Subject: RE: Question re: notifications to Davis Autobody - Turtle Lake

Wild Card Bar (former)

Case Closure Form 4400-202 (R 8/16)

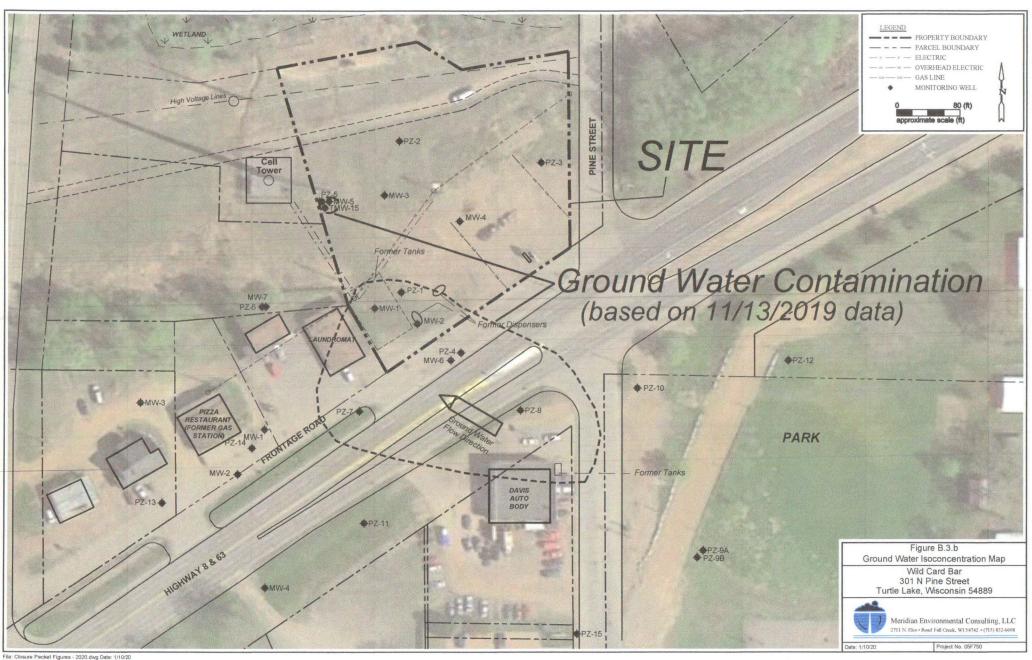
See attached GW extent map. I was NOT going to send notification to Davis Autobody and Village because we interpret the GW contamination on Davis Autobody and adjacent village street to be from Davis Autobody. We can not differentiate GW impacts from Wild Card site and Davis so we are treating as a co-mingled plume. I am sending notifications to adjacent laundromat and DOT only.

Does DNR agree?

HI Ken, I just left you a voicemail message. I showed this to John Sager. It would be hard to reopen Davis Auto Body-which has no GW samples and closed with a deed restriction for soils. We know all the plumes are co-mingled, so I would notify Davis, Village (Pine Street), whatever property is next to Wild Card and also notify Pizza Place. If you need to adjust PECFA costs let me know. Thanks, Carrie
